SSG Setting Schedule Consultation Response

Re: SSG Setting Schedule Consultation 11/01/2017

07/06/2017

2.5 Section 4.1 & Section 4.2

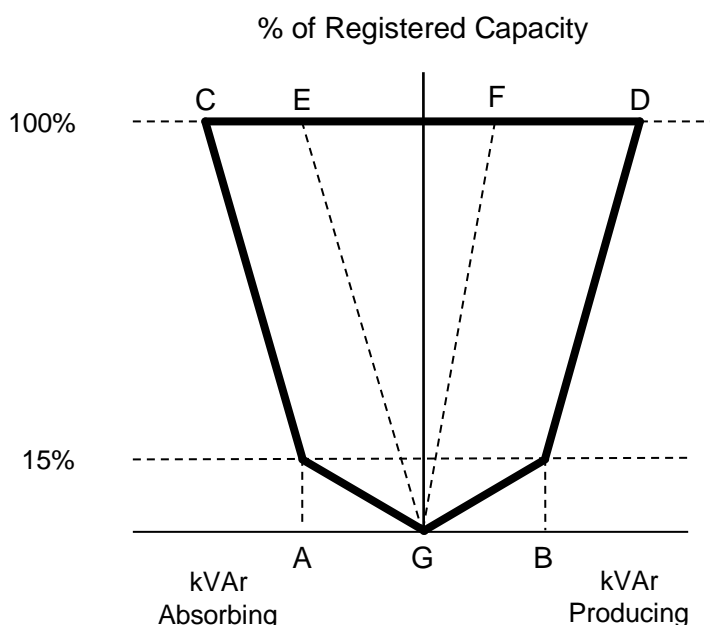
These points are not specifically requested during the application process on the Small-scale-generator-questionnaire-1st-Oct-2015.

They are also subject to change as complex customers add or remove equipment to a site. It is the reactive limits for the overall power station rather than just the generator.

The Setting Schedule has been updated to address these comments. The reactive power envelope shall be submitted following energisation. Although not specified in the Setting Schedule, this will normally be requested prior to controllability testing. NIE Networks considers that this may change in the future and it would not be appropriate to define the exact process within the Setting Schedule.
